**City of Fairhope
Planning Commission Agenda
5:00 PM
Council Chambers
November 5, 2018**

- A. SD 18.35 Public hearing to consider the request of North Hills at Fairhope, LLC for Preliminary Plat approval of North Hills at Fairhope, a 112-lot subdivision. The property is located on the north side of State Hwy. 104 approximately 1/2 mile east of County Road 13, to be known as North Hills at Fairhope.
PPIN #: 98367

NORTH HILLS AT FAIRHOPE
 SEPTEMBER 25, 2018 - SHEET 2 OF 3 SHEETS
 PRELIMINARY PLAT - NOT FOR RECORDING

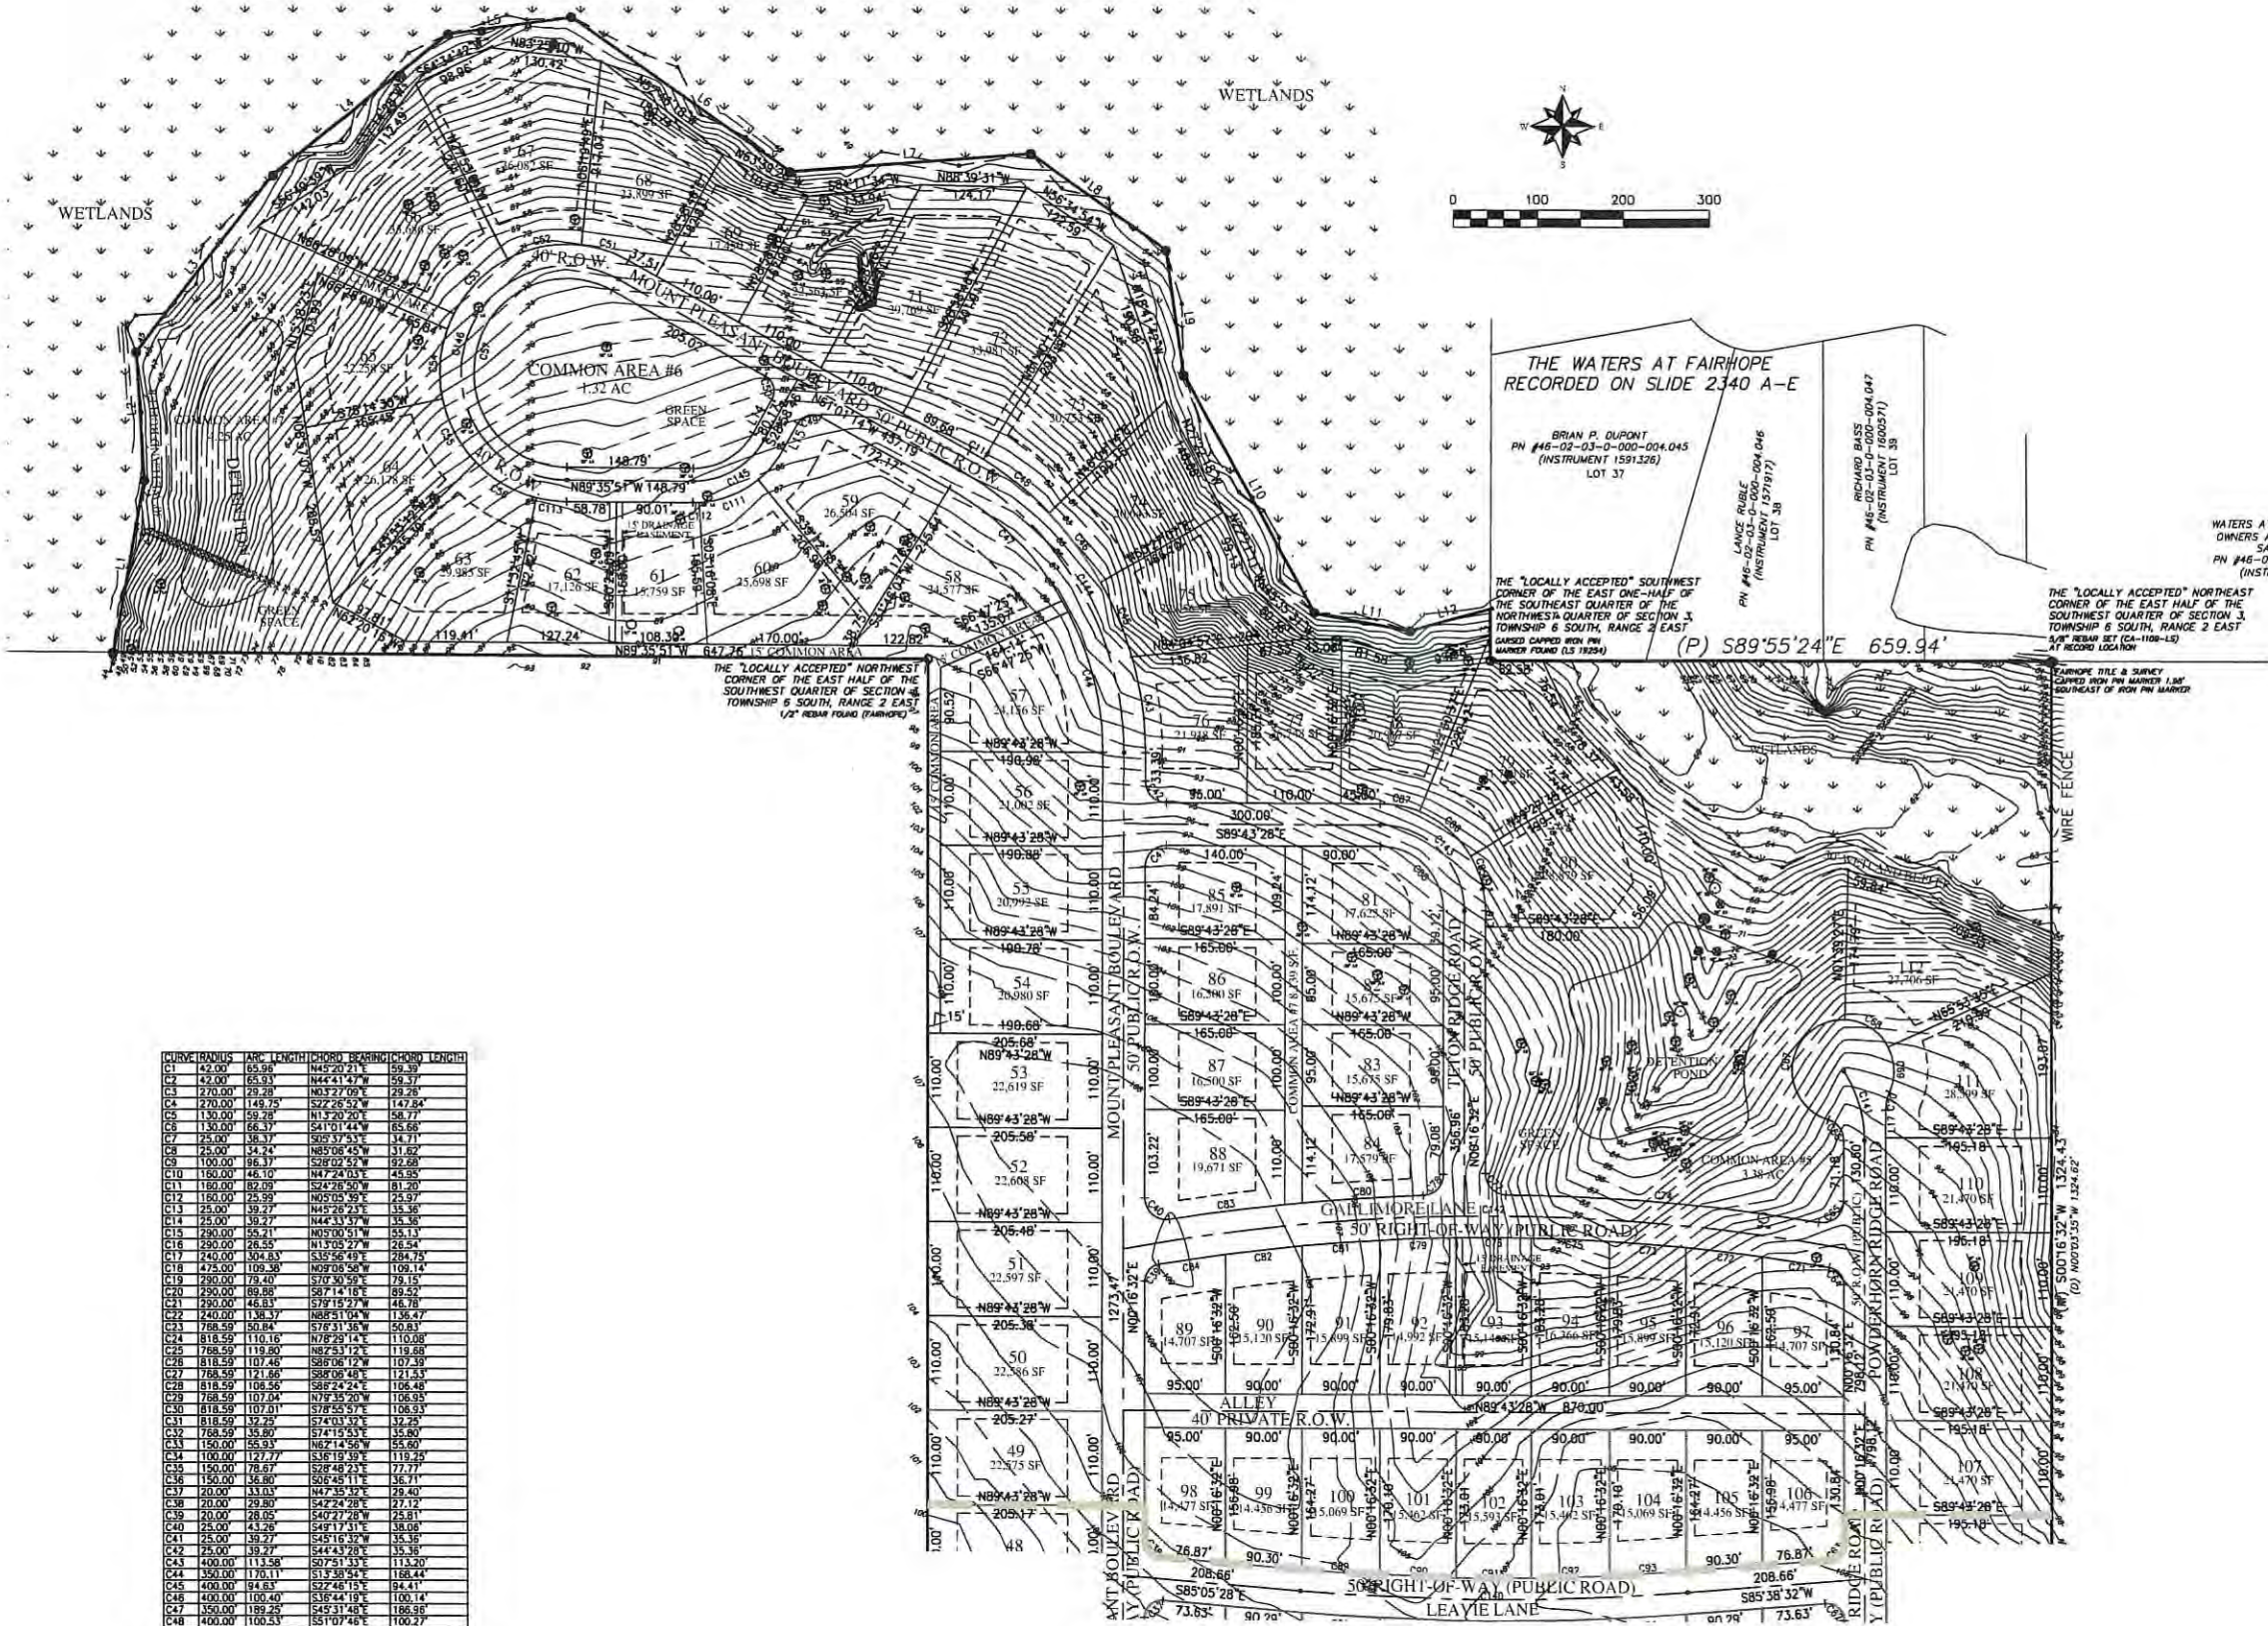
Comments: Please see the comments on sheet 2 of 3 of the preliminary plats. Please verify the 14.55% greenspace submitted does not include greenspace along the HWY 104 ROW. AL HWY 104 is a minor arterial according to the Eastern Shore MPO, and therefore greenspace adjacent to an arterial is not "counted" toward the greenspace requirements of section C2. The area adjacent to HWY 104 shall contain the 20' wide strip required by (and shall be labeled on the plat) according to COF ordinance 1444, Section 20.5-4 page "7" as the subject property is located along AL HWY 104. The site data table has been revised to reflect 12.6 acres, or 13.02% greenspace as required by this section. The applicant's follow-up narrative clarifies the greenspace adjoining Hwy 104 was removed from the greenspace total to attain the new 12.6 acre / 13.02% greenspace submission. Further, the 20' buffer strip required by Ordinance 1444 is reflected on the plat as well as a 10' sidewalk easement. Please reflect on the site data table the 1.46 acres of HWY 104 buffer area so that all common area components total 25.89 acres. Included on the revised preliminary plat as requested.
